LAGUNA HONDA HOSPITAL REPLACEMENT

SUMMARY OF COMMENTS AND RESPONSES

**Laguna Honda Hospital Replacement
Comments and Responses**

File No. 2000.005E

Proposed Site Plan (Revised)
 Draft EIR P. 2.0-13
 LAGUNA HONDA HOSPITAL REPLACEMENT EIR

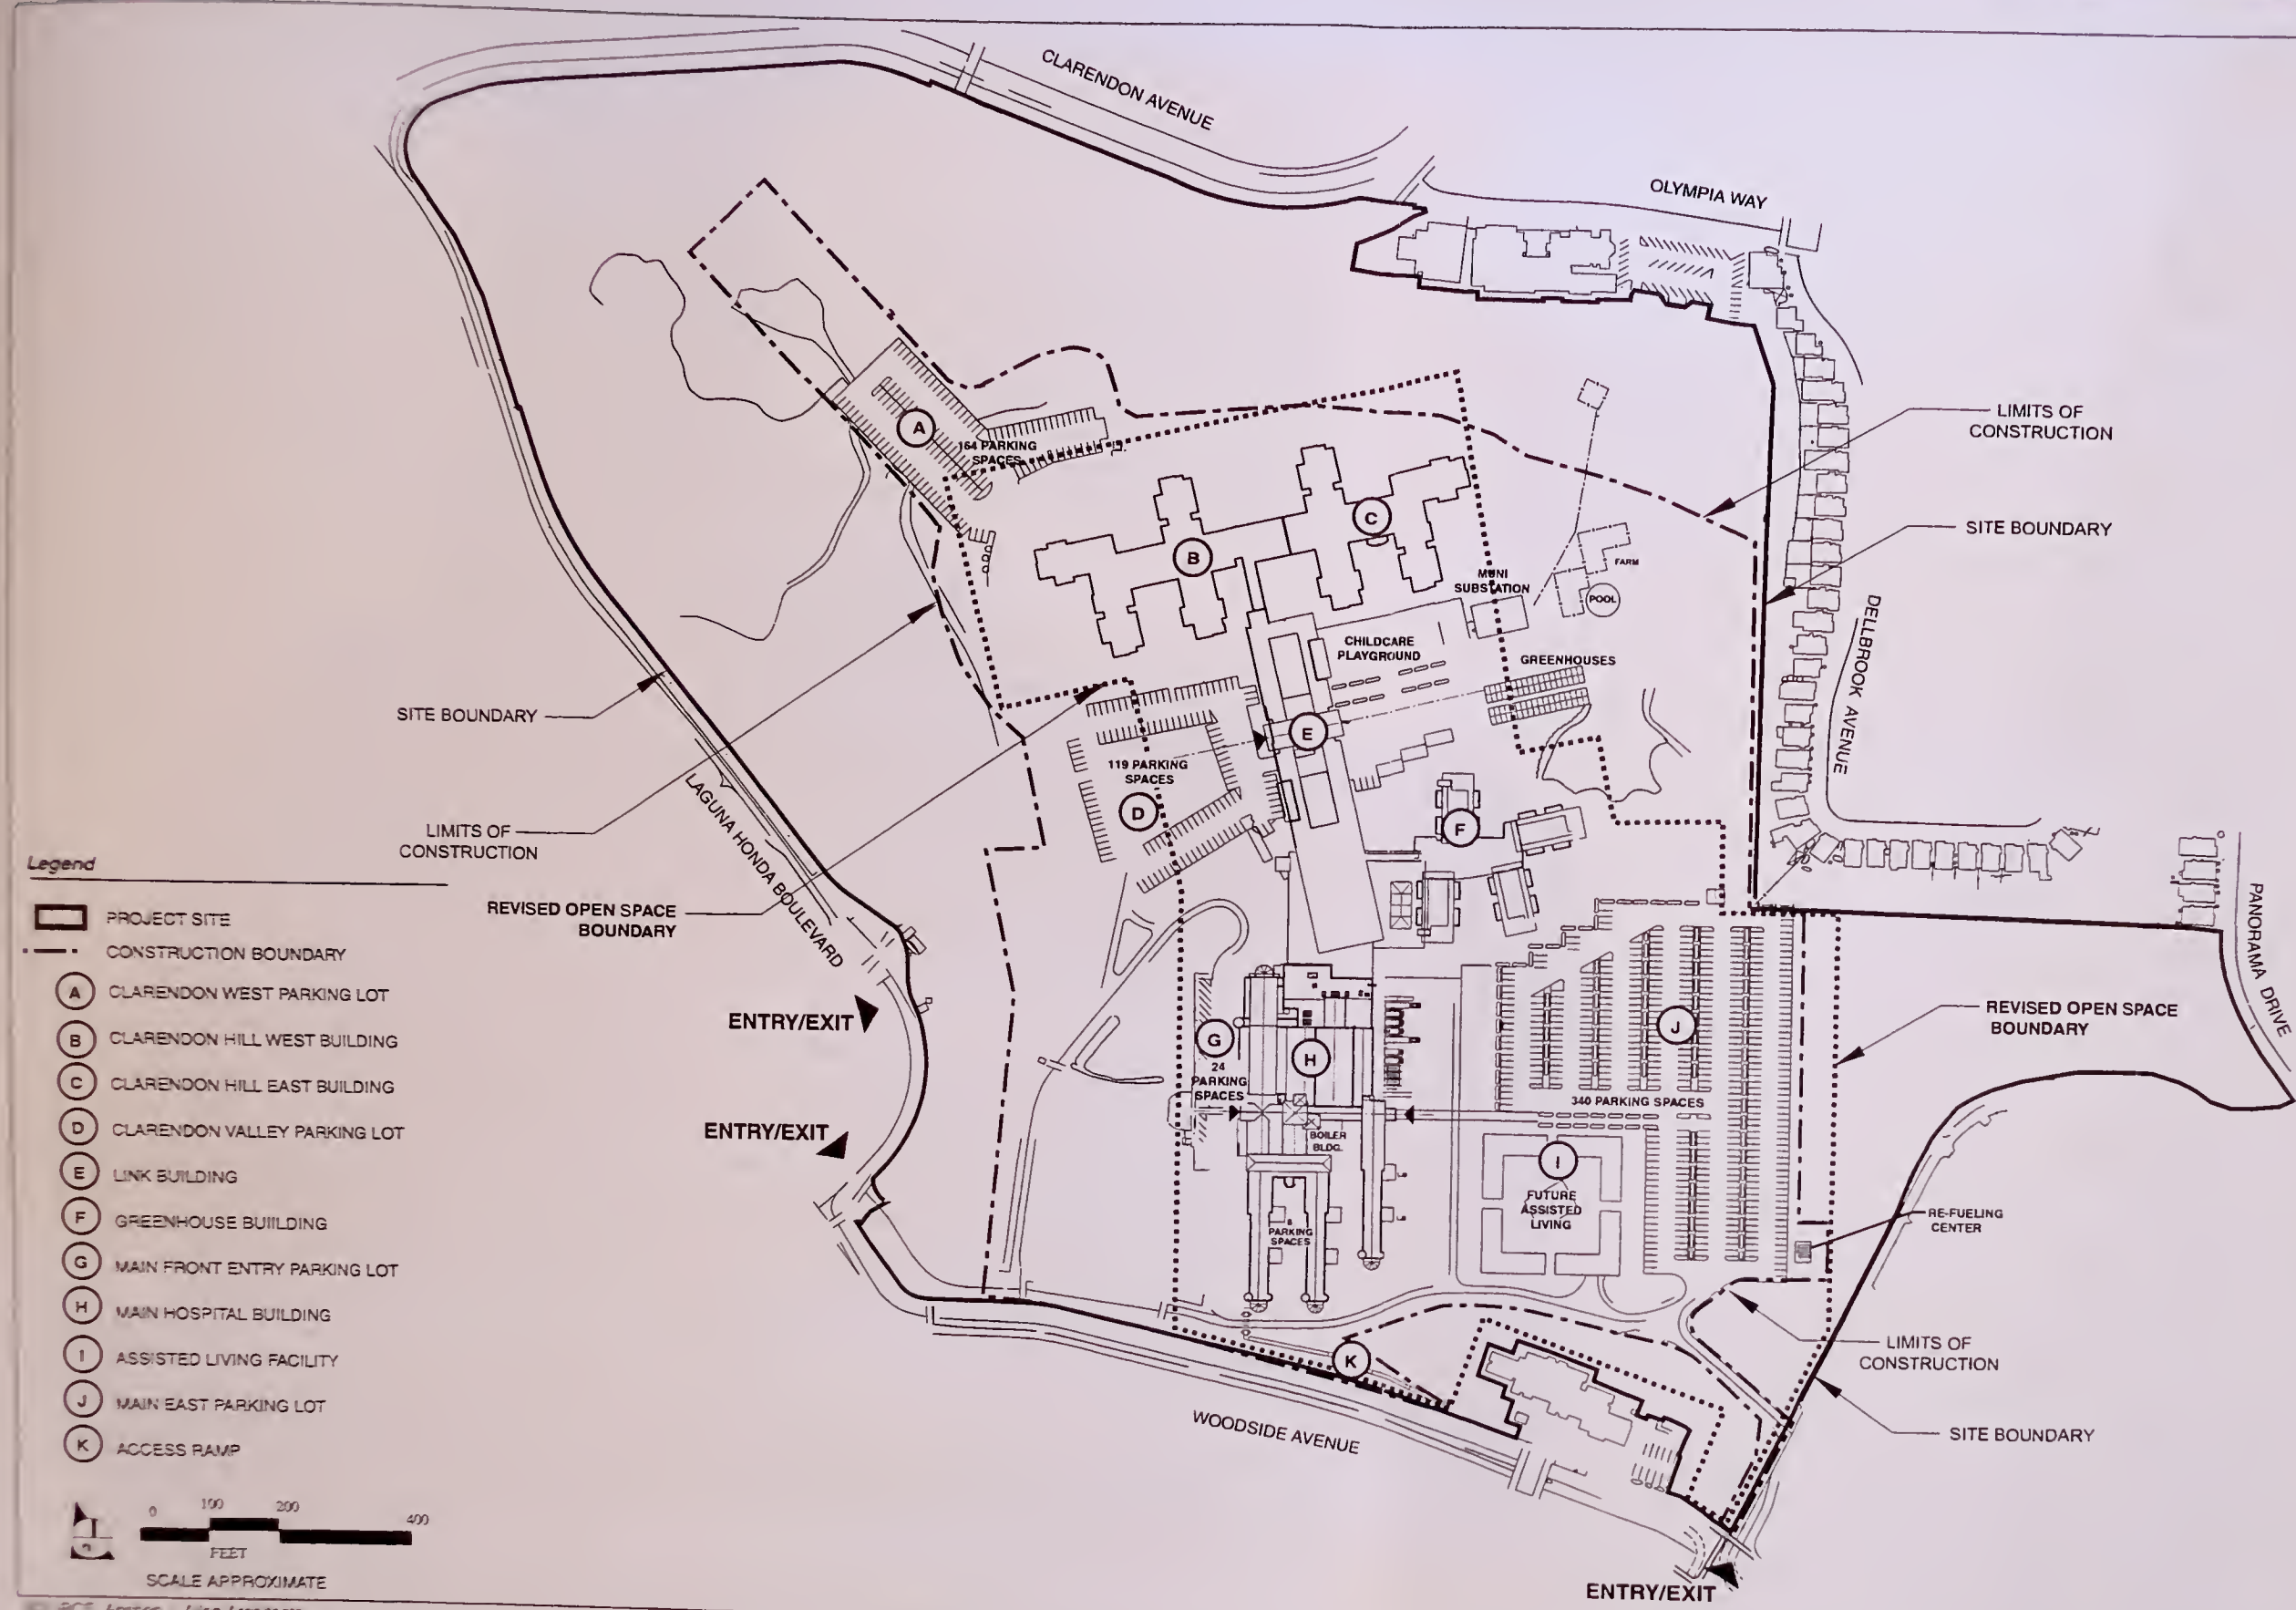
"p.2.0-5: 'a retaining wall of approximately 1,000 feet length...traverses the Woodside Avenue project boundary' This is the only mention of the wall in the EIR, although we understand that portions of the wall will be removed to accommodate ADA access to and from the site. Please clarify whether modification of this wall is included in the project scope and the design basis for the modifications, i.e. Improved access and project integration." Eileen Fanelli

"The Refueling Station and underground Storage Tanks, as shown on the Site Plan (p. 2.0-13) and the Phase B plan, would be located within less than 200 feet of the closest homes on Dellbrook Avenue, and at an elevation higher than some homes on that block. The report needs to state what safeguards would be incorporated in that installation to minimize the risk of tank rupture-and consequent leakage, contamination and fire danger-in case of a major earthquake. Also, what alternative site(s), farther removed from residences, have been considered, and the reason(s) for their rejection." Gilbert De La Mora, *et al.*

"The Proposed Site Plan (**Figure 2.0-4**, p. 2.0-13) shows, at the (south) eastern panhandle of the site, a northerly bulge extending into the private properties of #s 1154, 160, and 166 Dellbrook Avenue, and #s 201 through 227 Panorama Drive. Unless such a transfer to properties has taken place or is planned, this apparent drafting error needs to be corrected." **Gilbert De La Mora, et al.**

Figure 2.0-4 is hereby revised to show an access ramp from Woodside Avenue to the main entrance of the Main Hospital Building (see **Figure 2.0-4, Proposed Site Plan [Revised]**).

The location of the proposed re-fueling center shown on Figure 2.0-4, Proposed Site Plan, of the Draft EIR is incorrect. As shown on Figure 2.0-4, Proposed Site Plan (Revised), the re-fueling center would be located on the southeast corner of the Main East Parking Lot, approximately 500 feet from the property line of the nearest Dellbrook residents. The relocated re-fueling center would be about 200 feet further from the Dellbrook residents' property lines than the existing re-fueling station.

The project site boundary as shown on **Figure 2.0-4** is incorrect in the area noted by the commentor. As shown, the project boundary on the eastern portion of the campus should not extend to the north into the residential homes on Dellbrook Avenue. Please refer to **Figure 2.0-4 (Revised)** to view the correct project site boundaries.

Figure 2.0-4, Proposed Site Plan, is intended to show the proposed site plan and not existing conditions. For this reason, the existing vegetation shown on Figure 2.0-4 is in error and has been removed from the proposed site plan. Please refer to Figure 2.0-4, Proposed Site Plan (Revised).

Alternative One: Site Plan (Revised)

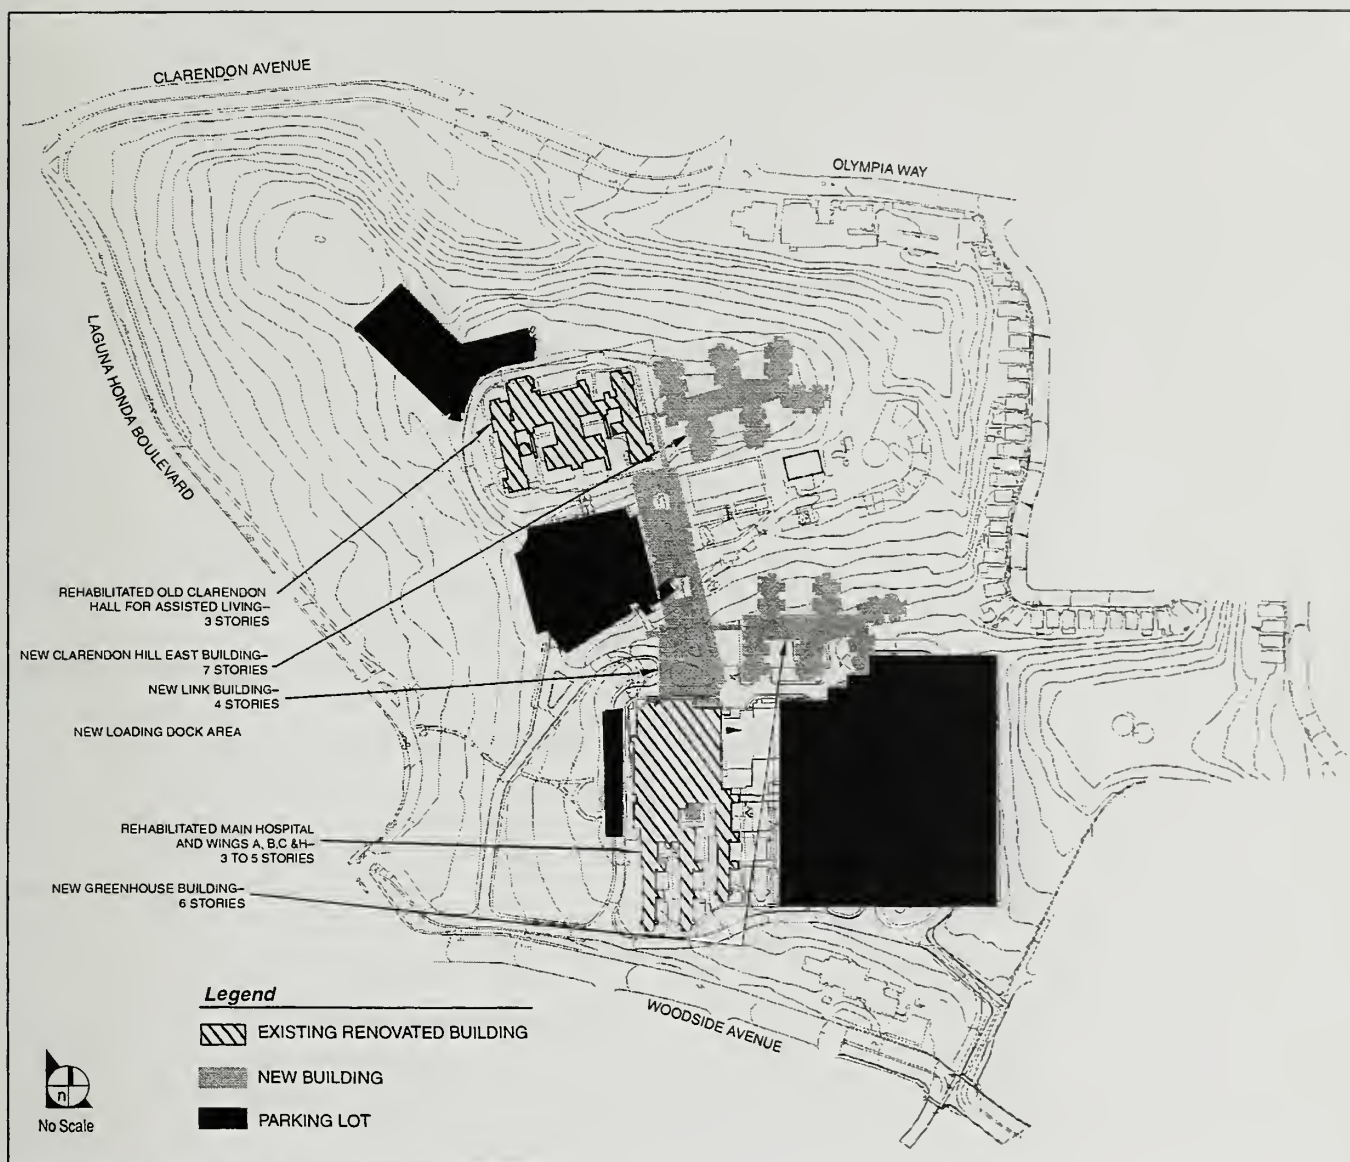
"The size of the satellite dishes currently located just east of the MUNI substation (Appendix 2.0-2, Phase B diagram) is such (see above mentioned photograph) that when relocated (Section E4(a), p. 2.0-16) to their new site in the (south-) eastern part of the campus near the water tanks (Figure 2.0-4, p. 2.0-13) they are likely to create a visual impact for a number of homes on Dellbrook Avenue and/or Panorama Drive.

In addition, Figures 6.0-1, Alternative One: Site Plan and 6.0-2, Alternative Two: Site Plan have been revised to removed the satellite dish complex from the graphics since the satellite dish complex would no longer exist on the hospital campus.
